## Ardmore Park Quarry

**Via Bungonia, NSW**

SUPPORTING DOCUMENTATION FOR A  
REQUEST TO MODIFY PROJECT  
APPROVAL PA 07\_0155

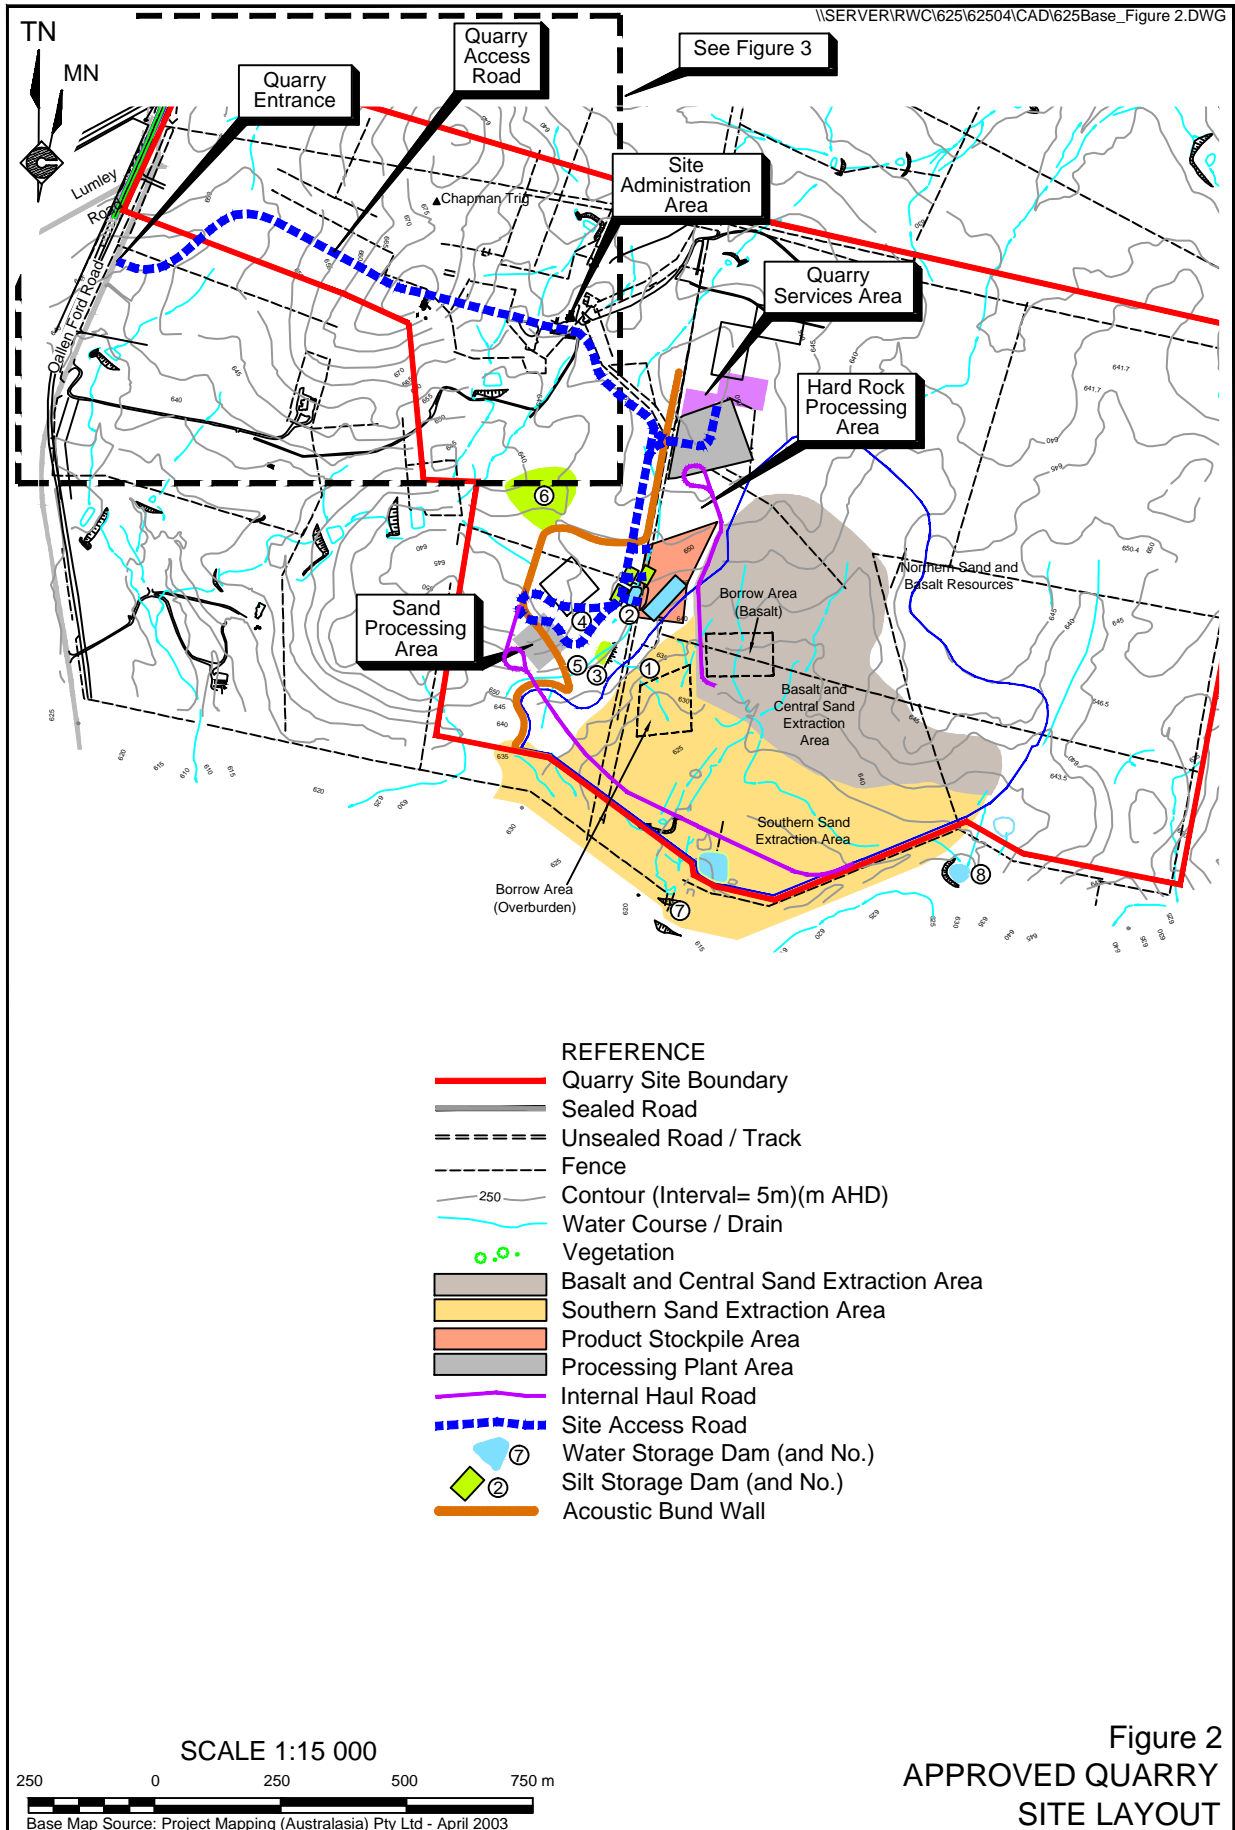
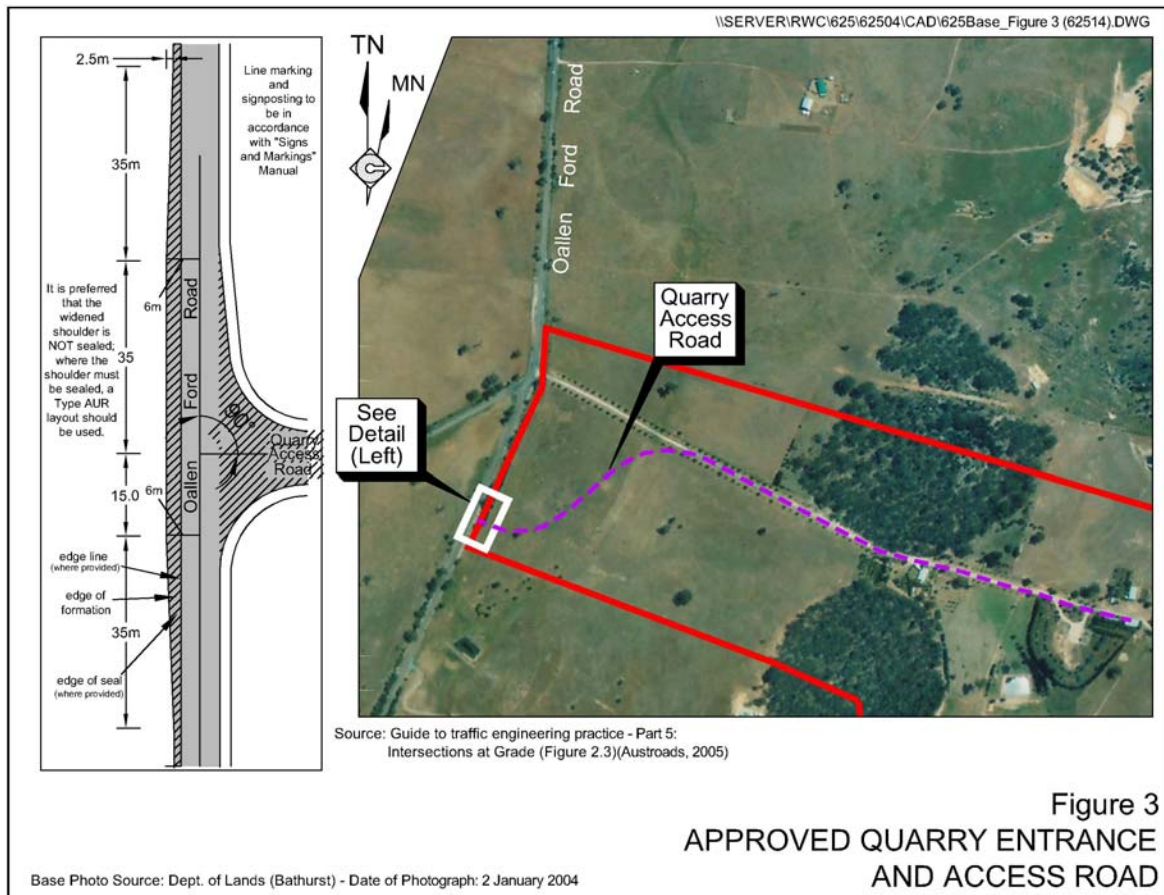
It is proposed to relocate the entrance to the quarry and change the alignment of the quarry access road from that shown in *Figure 2.1* and *2.15* of the *Environmental Assessment* for the Ardmore Park Quarry proposal (RWC, 2008) (see **Figures 2** and **3** of this report).

It is proposed to retain the entrance to the “Ardmore Park” property, with a minor realignment slightly south, to bring it directly opposite Lumley Road (see **Figure 4**).

This would create a single cross-junction intersection, as opposed to the two offset T-junctions provided for by the PA 07\_0155. While this intersection arrangement is not recommended by Australian Standard (AS) 2890.1-2004 (which provides guidelines for the location of access driveways), it is considered preferable in this circumstance as it would assist driver recognition of an upcoming intersection. The location of the Ardmore Park Quarry entrance at this junction would also optimise sight distance as it is on the outside of a curve.

**Figure 4** presents a conceptual intersection treatment based on the general form of a typical basic rural layout (type BA) of *Guide to Traffic Engineering Practice — Part 5: Intersections at Grade* of Austroads (2005). A final intersection design would be prepared prior to construction and would be subject to a Road Safety Audit to confirm the design meets the design and safety requirements specified in the RTA’s *Road Design Guide*.
